Flow Control Division

February 25, 2013

Subject: Wedge Pin Failure of an Anchor/Darling Double- Disc Gate Valve at Browns Ferry Nuclear Plant Unit 1

Figure 1
Typical Double-Disc Gate Valve Trim

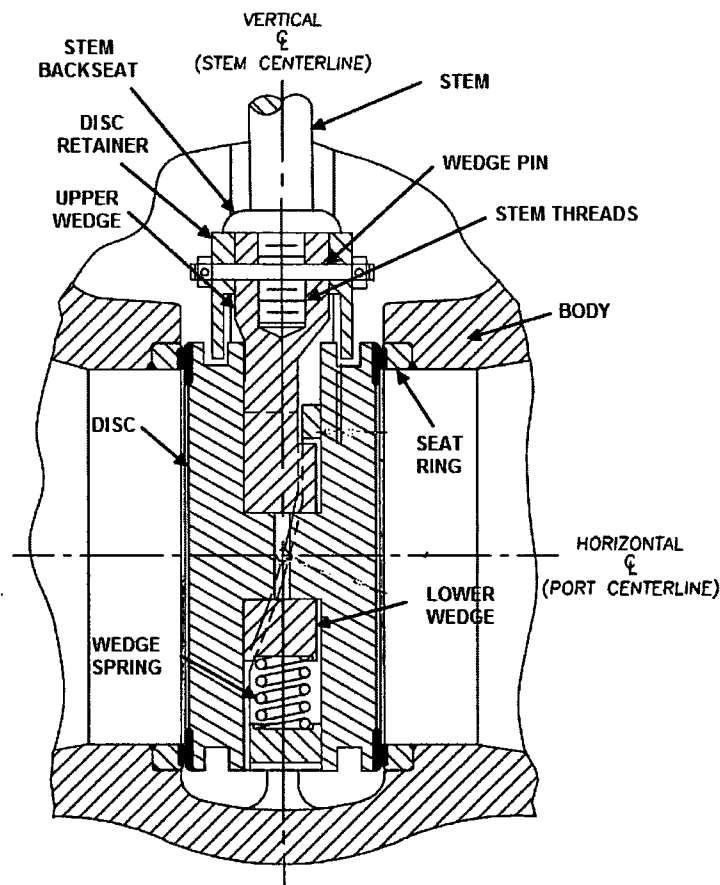
Flowserve has been working with the Tennessee Valley Authority's (TVA) Browns Ferry Nuclear Plant to investigate the failure of a Size 10, Class 900 Anchor/Darling motor-operated double-disc gate valve. The failure was due to the shearing of the wedge pin which serves a joint locking function at the threaded interface between the valve stem and upper wedge. The pin is designed to ensure that the joint does not loosen due to vibration and other secondary loads. On some valve designs, the pin also is used to attach the disc retainers to the upper wedge. The pin shearing allowed rotation of the stem during the closing stroke when the valve was seating and ultimately resulted in loss of the stem to upper wedge joint integrity.

Flowserve has completed an evaluation of the failure and concluded the root cause of the wedge pin failure was excessive load on the pin. The stem operating torque exceeded the torque to tighten the stem into the upper wedge before installation of the wedge pin. The additional stem torque produced a load on the wedge pin creating a stress which exceeded the pin shear strength causing the failure. The recommended assembly stem torque did not envelope the operating torque for the TVA application providing the potential for an over load situation and ultimate failure. The operating torque for the TVA valve was unusually high due to the fast closing time of the actuator and very conservative closing thrust margin.

The stems on most double-disc (DD) gate valves larger than size 2" are attached to the upper wedge using UN threads. A pin is installed through the hub of the upper wedge and stem threaded section to prevent the stem from loosening and eventually unscrewing from the wedge. In addition, the disc retainers on some DD gate valves are attached using the wedge pin. See Figure 1. The output torque of the actuator is transmitted to the stem/wedge joint through the stem and is resisted by the disc wedge pack, therefore the stem to wedge connection is loaded by the stem torque and thrust. The wedge pin is not designed to withstand the full actuator output torque. The actuator torque direction tends to tighten the stem into the wedge during closing and tends to loosen the stem during opening.
